STAFF REPORT: REGULAR CALENDAR

APPLICATION NO. 4-00-218
APPLICANT: Los Angeles County Department of Public Works
AGENT: Brian D. Hooper
PROJECT LOCATION: 5940 De Butts Terrace, Malibu, Los Angeles County

PROJECT DESCRIPTION: Remove damaged outlet and energy dissipater at top of slope and install a 350 ft. long connector pipe to reroute runoff; construct energy dissipater at end of pipe; and restore eroded slope. Project includes 1720 cu. yds. of grading (20 cut, 1700 fill).

EXHIBIT NO. 4
APPLICATION NO.
4-00-218 (LACD)
VISUAL IMPACTS

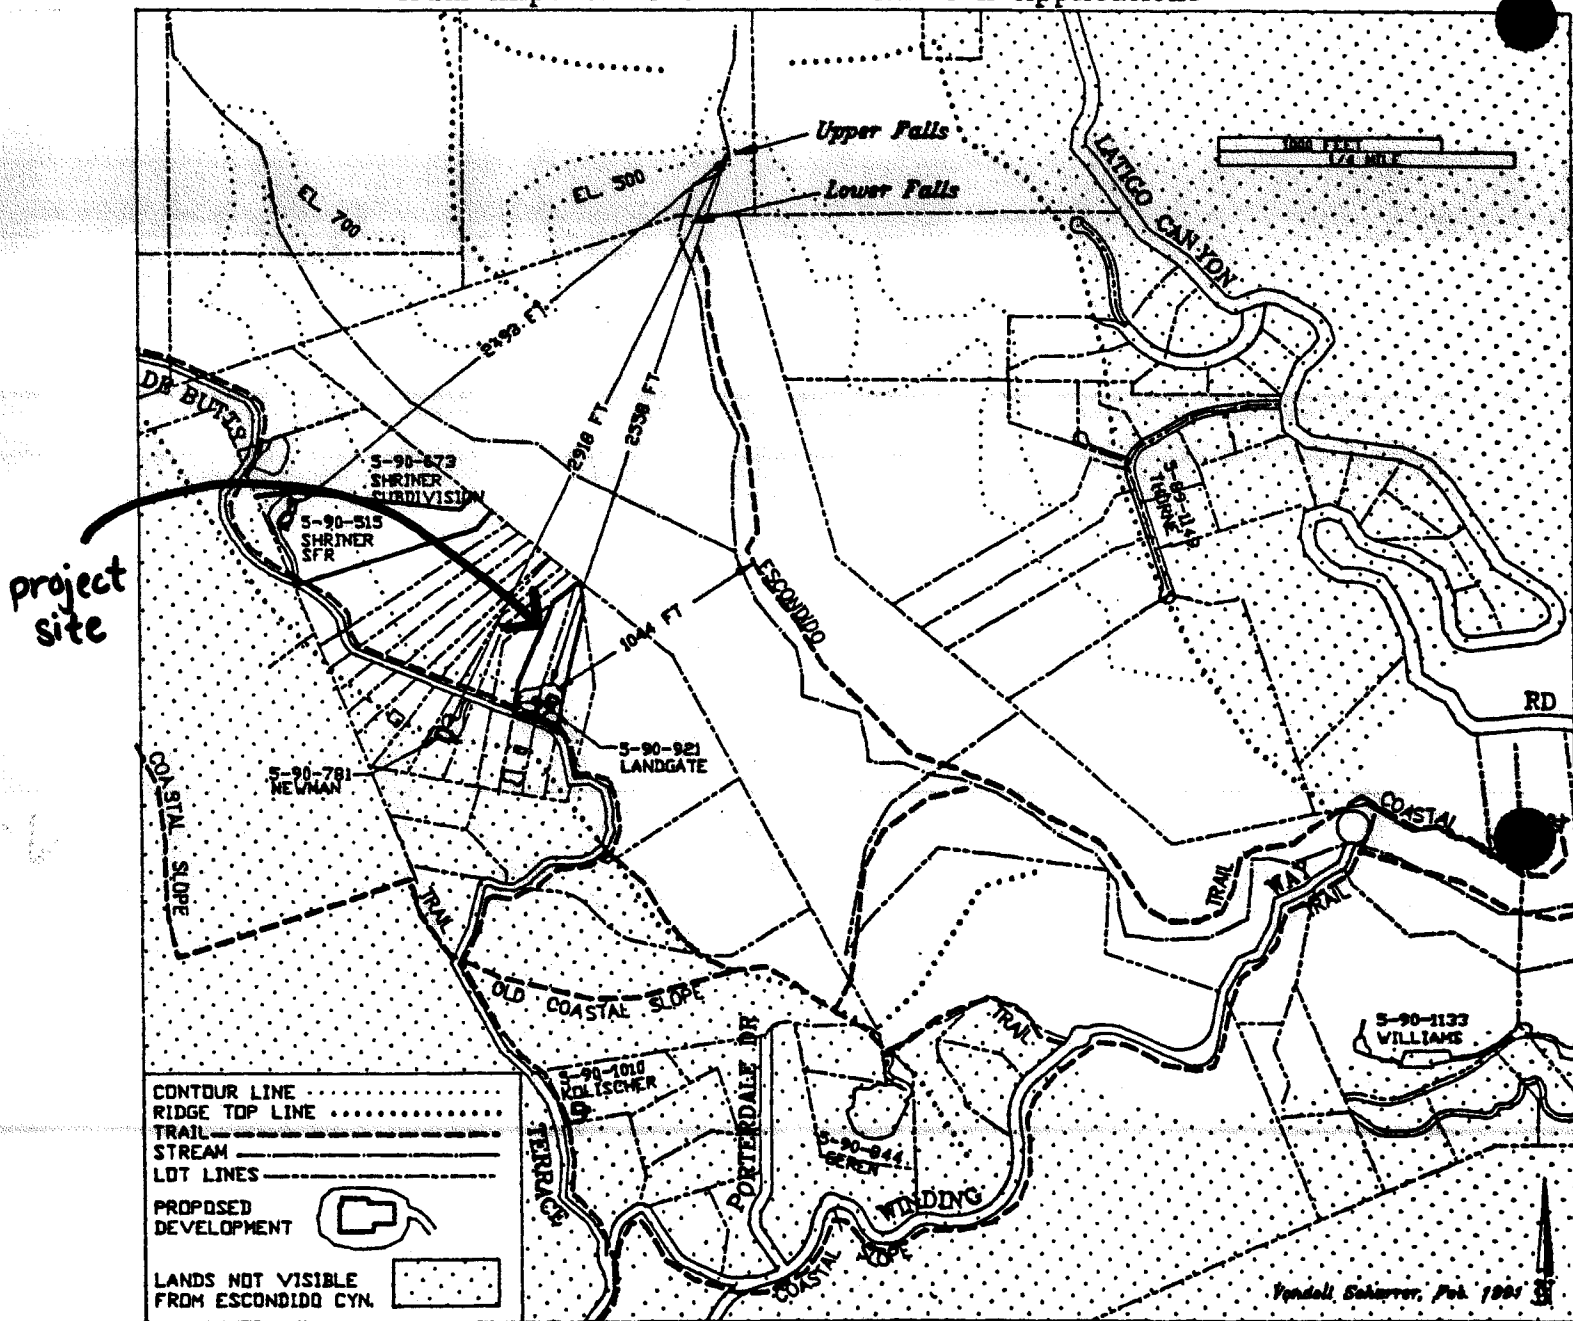
The project site overlooks Escondido Canyon and is visible from a popular and highly scenic trail to Escondido Falls (Exhibit 4). The visual impact of development onto the trail viewshed has been a concern in past Commission actions (CDP 4-97-179, De Butts and Associates; CDP 5-90-921, Landmark Inc.; CDP 5-90-515 and CDP 5-90-673, Shriner). The Commission has consistently conditioned permits for residential development in this area to mitigate and minimize visual impacts. While these permits concerned residential developments, other developments, such as clearing of vegetation, grading, and construction of fences, retaining walls, bridges and other non-residential structures, also produce visual impacts and have required special conditions for approval (CDP 4-99-169, Trento; CDP 4-97-216, LACPWD). Grading associated with the proposed project will be visible from the trail and disrupt the visual continuity of the undeveloped hillside, as will the proposed 250 sq. ft. energy dissipater. To minimize the visual impact of the proposed development, **Special Condition 1(a)** requires the applicant to plant all graded and disturbed areas with native vegetation consistent with the surrounding coastal sage shrub habitat. In addition, **Special Condition 2(d)**

requires the applicant to submit design specifications for the energy dissipater consistent with the color and texture of the surrounding hillside.

EXHIBIT NO. 5(c)
APPLICATION NO.
 4-00-218 (LACDPW)
CONSTRUCTION DETAILS

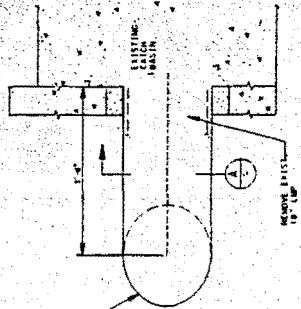
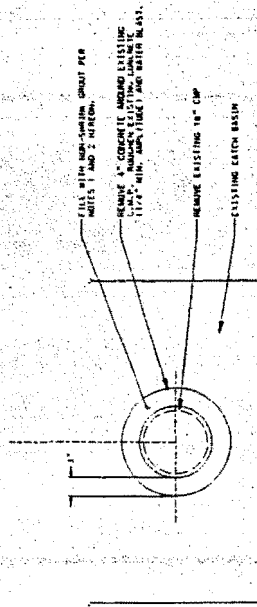
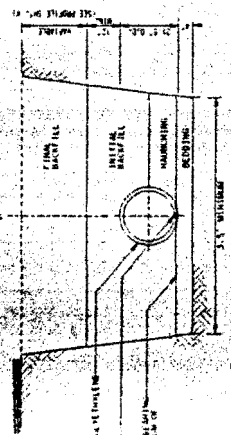
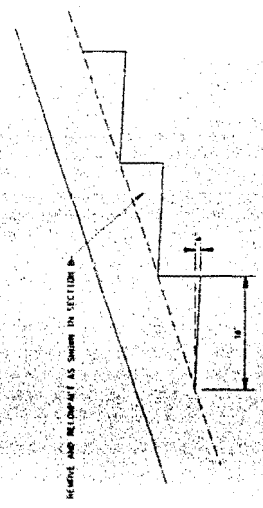
The applicant proposes to remove a damaged drainage culvert outlet, replace it with a drainage pipe and riprap energy dissipater, and restore an eroded slope at 5940 De Butts Terrace. The culvert conveys runoff from De Butts Terrace to the western slope of Escondido Canyon. The project includes removing the damaged energy dissipater and outlet, attaching a 350 foot long connector pipe to the existing catch basin, installing an energy dissipater at the end of the pipe, and placing 1700 cu. yds. of fill in the eroded channel. The connector pipe will be installed about 50 feet east of the erosional feature, and terminate approximately 300 feet downslope, at a point where the erosion damage returns to the natural drainage course. The proposed energy dissipater is an impact basin with vertical baffle wall and ¼ ton of riprap on a concrete platform. It is 25 ft. long and 10 ft. wide (Exhibit 5c).

In addition, the Commission notes that the proposed energy dissipater is of similar design to the dissipater being replaced. Failure of the original energy dissipater resulted in the erosion of an approximately 10-foot deep gully. In addition to other site stability

- (d) The plan shall included design specifications compatible with the color and texture of the surrounding hillside. The energy dissipater shall be designed to include, or mimic, the native materials and appearance of the natural environment, and shall be of an earthtone color. White tones shall not be acceptable.
